Product Group: SIL/Fri Nov 1, 2024/PIN-SIL-057-2024-REV-0

Datasheet Revision with Spirito SOA for Commercial MOSFETs (Phase-04)

Product Information Notification

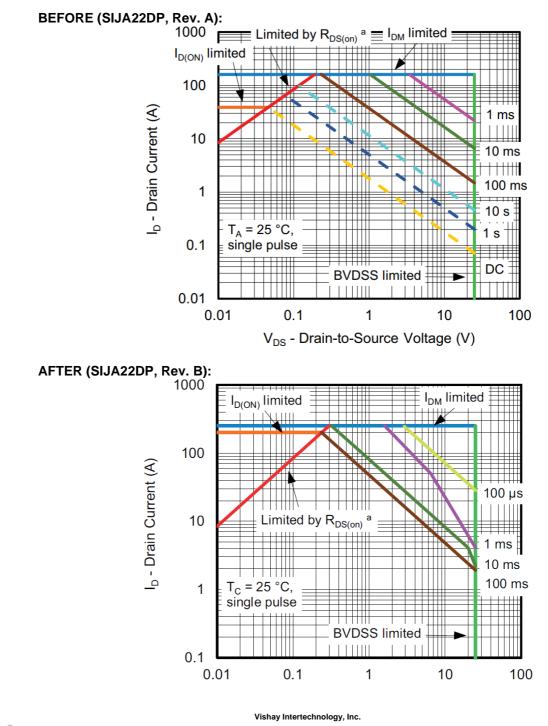
EXPECTED INFLUENCE ON QUALITY/RELIABILTY/PERFORMANCE: There will be no effect on quality, reliability, performance, and the minimum/maximum values in the datasheet.

| Vishay Part Number | Datasheet Revision | |
|--------------------|--------------------|--------|
| SIJA22DP-T1-GE3 | Rev. A | Rev. B |

BEFORE (SIR510DP, Rev. D):

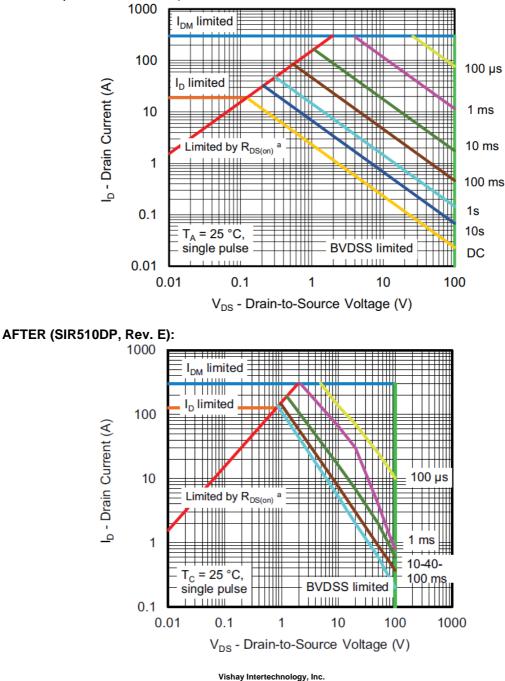
EXPECTED INFLUENCE ON QUALITY/RELIABILTY/PERFORMANCE: There will be no effect on quality, reliability, performance, and the minimum/maximum values in the datasheet.

| Vishay Part Number | Datasheet Revision | |
|------------------------------------|--------------------|--------|
| SIR510DP-T1-BE3 SIR510DP-T1-RE3 | Rev. D | Rev. E |

BEFORE (SIR5607DP, Rev. B):

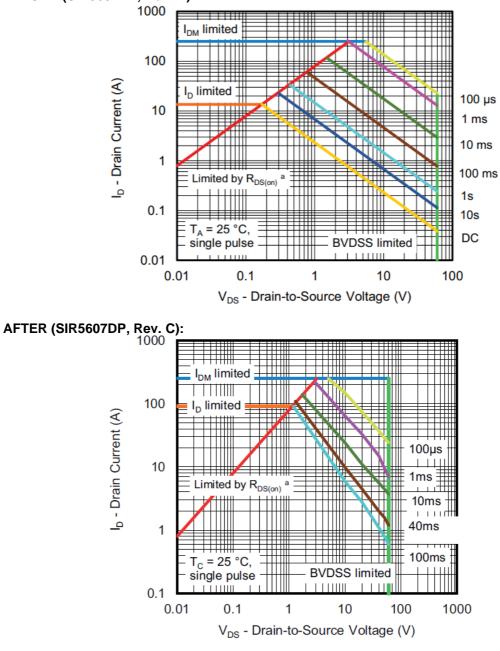
EXPECTED INFLUENCE ON QUALITY/RELIABILTY/PERFORMANCE: There will be no effect on quality, reliability, performance, and the minimum/maximum values in the datasheet.

| Vishay Part Number | Datasheet Revision | |
|--------------------|--------------------|--------|
| SIR5607DP-T1-RE3 | Rev. B | Rev. C |

BEFORE (SIR870ADP, Rev. B):

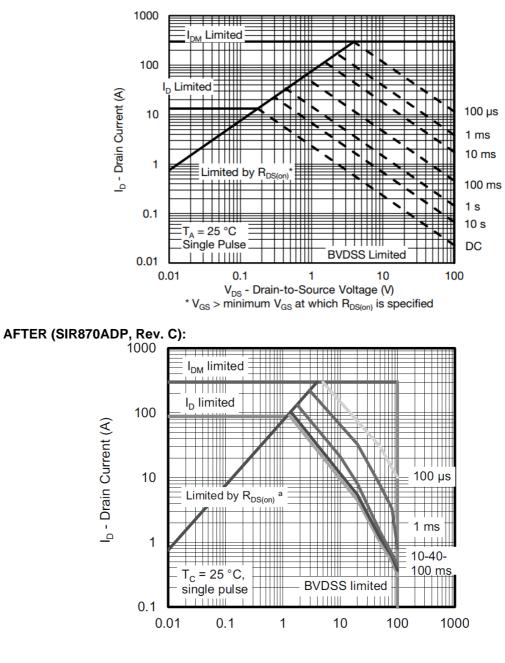
EXPECTED INFLUENCE ON QUALITY/RELIABILTY/PERFORMANCE: There will be no effect on quality, reliability, performance, and the minimum/maximum values in the datasheet.

| Vishay Part Number | Datasheet Revision | |
|--------------------|--------------------|--------|
| SIR870ADP-T1-GE3 | Rev. B | Rev. C |

BEFORE (SIR872ADP, Rev. A):

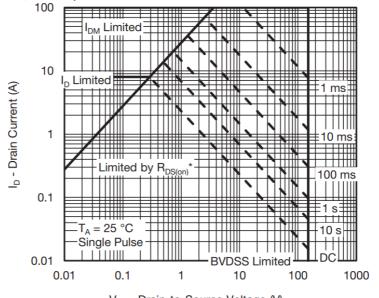
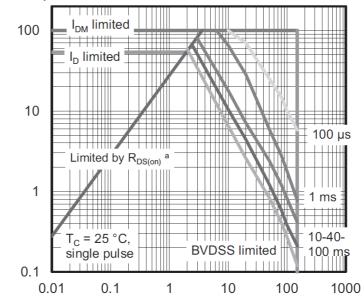
EXPECTED INFLUENCE ON QUALITY/RELIABILTY/PERFORMANCE: There will be no effect on quality, reliability, performance, and the minimum/maximum values in the datasheet.

| Vishay Part Number | Datasheet Revision | |
|--------------------|--------------------|--------|
| SIR872ADP-T1-GE3 | Rev. A | Rev. B |

AFTER (SIR872ADP, Rev. B):
